## **CHAMPION HILLS SUBDIVISION,**

### **UNIT 2**

APPLICATION NUMBER 7 DATE October 19, 2006

# DETAIL SITE PLAN

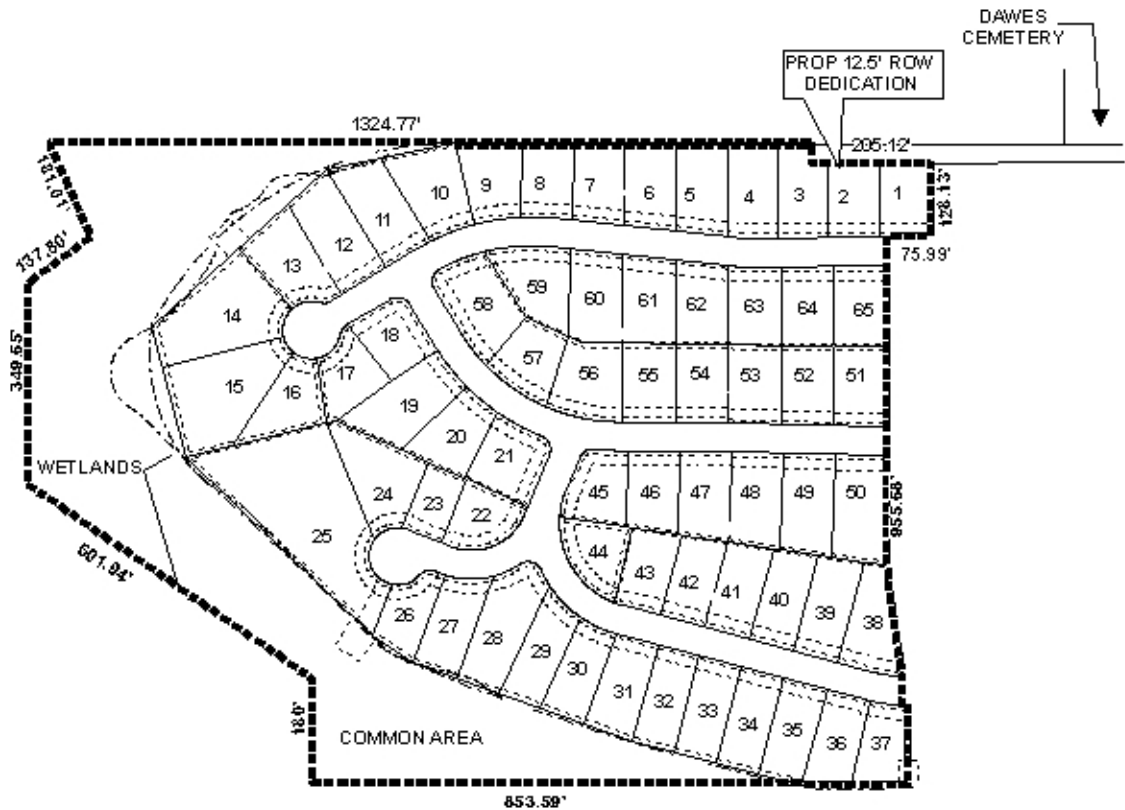
The site adjoins Dawes Cemetery Road, which has an existing right-of-way of 25-feet; therefore, the dedication of adequate right-of-way to provide 25-feet from the centerline should be required.

As with any double fronting lots, Lots 1-3, should be denied direct access to Cemetery Road

The site as proposed extends from three street stubs of Labrador Run North, Labrador Run South, and Sir Brutus Run, all minor streets with adequate right-of-way. The extension of streets into the proposed development will create cul-de-sacs approximately 800 feet and longer, that exceeds the 600 foot length recommended in Section V.B.6. of the Subdivision Regulations. With the provision of a traffic calming device approved by Mobile County Engineering near the midpoint of these streets, waivers of Section V.B.6. may be appropriate.

The overall site is bounded by a undeveloped parcel to the southwest. The development, as currently designed, does not provide access or street stubs to this parcel (in the area of Lots 25 and 26). However, this parcel is owned by a utilities company and would cross a designated wetlands area; therefore, no street stub would be required.

It appears that each lot meets the minimum size requirements for developments with access to public water and sewer. Due to the size of the proposed development, it is requested that the applicant revise the preliminary plat to provide the size of each lot in square feet on the plat, either as a table or as a label for each individual lot.

As illustrated on the preliminary plat, the site contains a large wetlands area; therefore, the approval of all applicable federal, state and local agencies should be required. Common areas and detention areas are depicted on the preliminary plat. All common areas, whether

greenspaces, detention areas, or other, should be labeled as such, and a note should be placed on the final plat, if approved, stating that maintenance of all common areas shall be the responsibility of the subdivision's property owners.

The plat is recommended for Tentative Approval, subject to the following conditions: 1) the dedication of sufficient right-of-way to provide 25-feet as measured from the centerline of Dawes Cemetery Road; 2) placement of a note on the Final Plat stating that Lots 1-3 are denied direct access to Dawes Cemetery Road; 3) provision of a traffic calming device near the midpoint of Labrador Run North, Labrador Run South and Sir Brutus Run with the size, design and location to be approved by Mobile County Engineering; 4) provision of a certification letter from a licensed engineer to the Planning Section of Urban Development, certifying that the stormwater detention, drainage facilities, and release rate comply with the City of Mobile stormwater and flood control ordinances, prior to the signing and recording of the final plat; 5) labeling of all lots with size in square feet, or provision of a table with the lot size information on the plat; 6) the approval of all necessary federal, state and local agencies; and 7) placement of a note on the Final Plat stating that any lots which are developed commercially and adjoin residentially developed property must provide a buffer, in compliance with Section V.A.7. of the Subdivision Regulations.
